# Town of Simsbury

**RE:** ZC 23-26, 530 Bushy Hill Rd. Raising Cane's St. Site Plan and Special Exception

## DESIGN REVIEW MEMORANDUM

**To:** George K. McGregor, AICP, Director of Community Planning and Development  
**From:** Adam D. Kessler, P.E., Deputy Town Engineer   
**Subject:** **Engineering Comments – Proposed Commercial Development  
#530 Bushy Hill Road**

### Site Plan

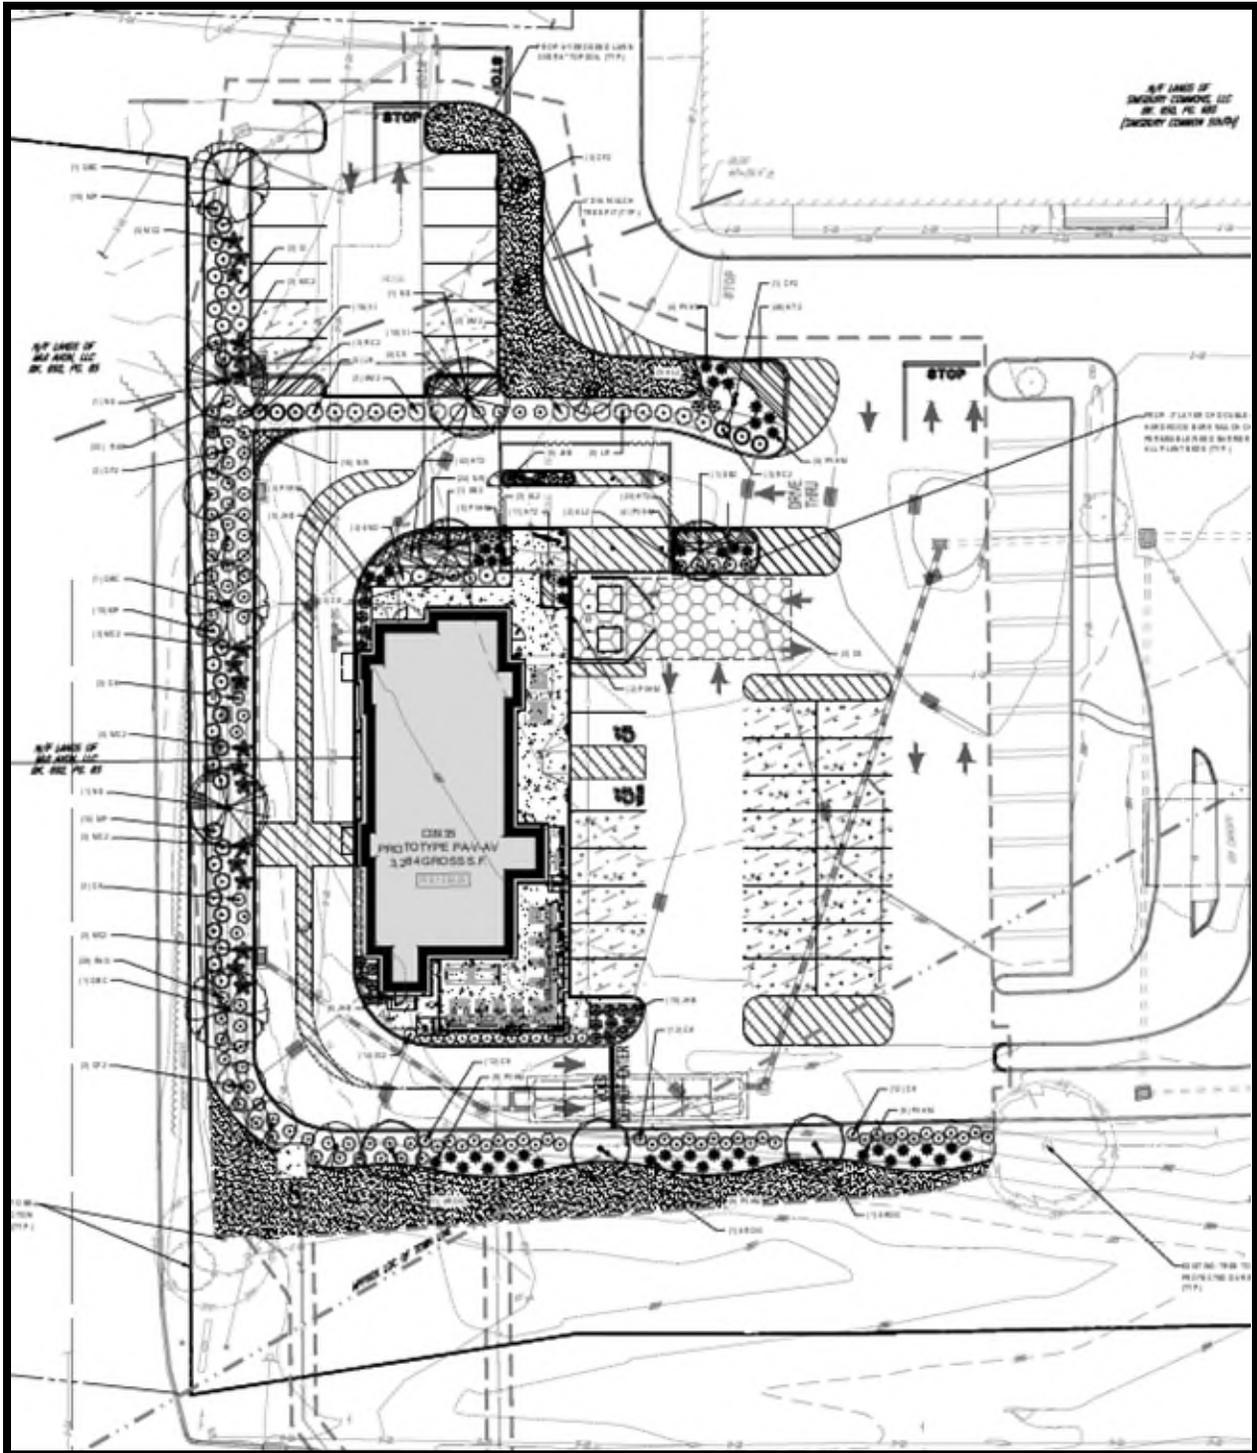
3. Identify the use for the 12 separate parking spaces to the north of the proposed building. These parking spaces should have a connection via sidewalk and crosswalks, if applicable, for pedestrian traffic to the building(s) of which they are intended for.
4. A stop bar is proposed to be relocated to the north of the proposed parking lot with 12 parking spaces. This stop bar has an existing associated stop sign which is proposed to be removed. Provide the relocated location of this stop sign or compliance with MUTCD.
5. The construction entrance / anti tracking pad location shall be identified on Sheet C-601.

8. The two-lane ATM drive thru from the “Santander Bank” to the east will have egress from their site directly into the proposed parking lot. Additionally, a single lane exists to the south of that two-lane egress. Additional pavement markings and/or signage may be warranted to prevent future traffic conflicts.

9. The egress of the parking lot to the north appears to have two 10-foot wide lanes. If this is the intention, identify the lane with appropriate pavement markings.

10. Verify parking space count. Double row of 8 spaces includes a typo on Sheet C-301.
11. On Sheet C-301 a call-out for Note G exists on the plan but not the Legend. Verify all call-outs and revise accordingly.

**Response: This parking lot is to be utilized by employees and overflow for the proposed restaurant. Sheet C-301, Site Layout Plan has been revised to include sidewalks and a crosswalk.**

**Response: A callout for the relocated stop sign has been provided on Sheet C-301, Site Layout Plan.**

**Response: Note has been added to Sheet C-301, Site Layout Plan.**

**Response: Acknowledged, applicant is coordinating with the adjacent parcel to relocate the banks directional signage.**

**Response: Pavement markings have been revised to display a "left only" and "right only" at the egress of the parking lot. See Sheet C-301, Site Layout Plan.**

**Response: The Zoning Analysis table has been revised to display 36 parking spaces Sheet C-301, Site Layout Plan.**

**Response:** Legend has been updated to state “Proposed Conc. Walk” for the callout G on Sheet C-301, Site Layout Plan.
